PLANNING COMMISSION STAFF REPORT

TRAILSIDE ESTATES – DESIGN PLAN

TRAILSIDE ESTATES SUBDIVISION DESIGN PLAN

TRAILSIDE ESTATES SUBDIVISION
MIAMI TOWNSHIP, CLERMONT COUNTY, OHIO
LOT LAYOUT

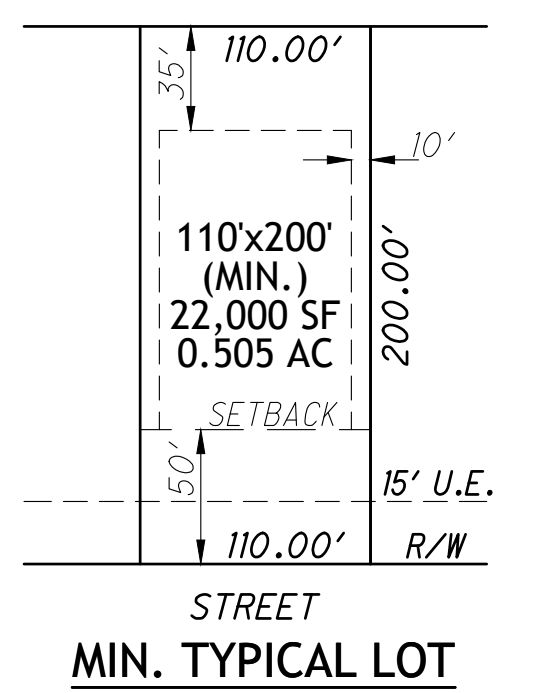
1. The normal permissible frontage for any lot in a platted subdivision shall be twenty-five feet (25'), but a narrower width is permissible where it can be demonstrated that lots can be served with adequate utilities. Lot 14 appears to have a lot width of twenty feet (20') that is fully covered by a sanitary sewer easement. This should be shifted to allow for a driveway and/or other utilities.
2. Section 514(A)(3) of the Clermont County Subdivision Regulations states that sidewalk requirements shall be waived whenever the Planning Commission determines them to be a direct threat to the public health, safety, or general welfare (see CCEO comment #4).
3. Any future development of the site must comply with any and all regulations from Clermont County, Miami Township, the State of Ohio, or any other applicable agency.

1. Guard Rail may be required along Wards Corner Road adjacent to both proposed Storm Water Management Ponds.
2. Additional Right-of-Way along Wards Corner Road needs to be provided. A minimum 25-Foot Half Right-of-Way needs to be maintained.
3. Sight Distance Analyses need to be provided for the Proposed Street A and the Proposed Private Drive, located along Wards Croner Road.
4. Wards Corner Road falls under Clermont County jurisdiction. Given the nature of this roadway at this location, it is our recommendation that sidewalk NOT to be installed within the Public Right-of-Way.
5. A general reminder regarding roadway geometry; the minimum allowable street grade is 0.4%, maximum street grade is 12% (10% preferred), and the minimum centerline curve radius is 200'.

1. Geotechnical studies will be required for all construction on sensitive soils as defined by the Clermont County Subdivision Regulations (EbG2 and HkF2 soils)
2. Easements will be needed for all storm sewer infrastructure located outside the public road R/W, including the stormwater management basins.
3. An armored ditch/swale will likely be needed between the two stormwater management basins. This can be addressed in the construction drawings.
4. Given the Genessee soils in the vicinity of the western stormwater basin, there may be an opportunity to use infiltration practices to improve stormwater management.
5. Clermont Soil and Water would be supportive of reduced setbacks to protect hillslides (Lots 16-18) if also supported by Miami Township and other reviewing agencies.

TRAILSIDE ESTATES SUBDIVISION
MIAMI TOWNSHIP, CLERMONT COUNTY, OHIO
UTILITY LAYOUT

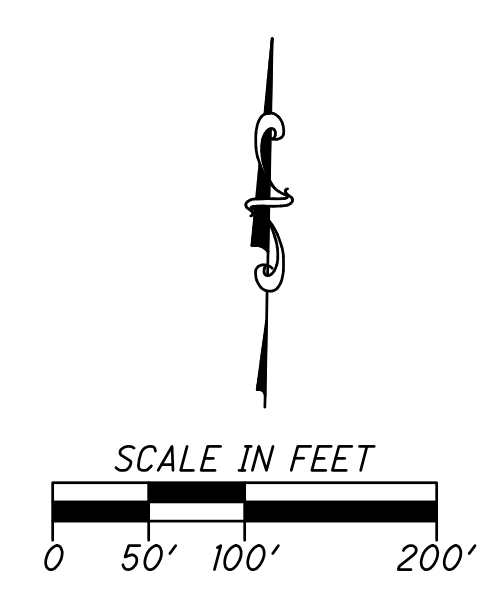
1. The sanitary sewer to Trailside is dependent upon Hawley Farms construction and finishing of the proposed sanitary sewer in compliance with CCWRD standards. At the moment there is no "Existing Sanitary Sewer" available to Trailside Estates.
2. Sanitary Sewer Easements are missing where the sanitary sewer is outside of the general utility easements.
3. The Sanitary Sewer easement along the property lines for lots 13 & 14 will need to be reconfigured to allow access for other utilities.
4. Fire hydrant easements are required on all fire hydrants in compliance with CCWRD standards.
5. Provide profile sheets with material, size and slope for sanitary sewer and water mains.
6. Provide locations of sanitary sewer laterals and water services.
7. Provide all necessary general notes and sheets including the CCWRD rules and regulations, specifications and details.
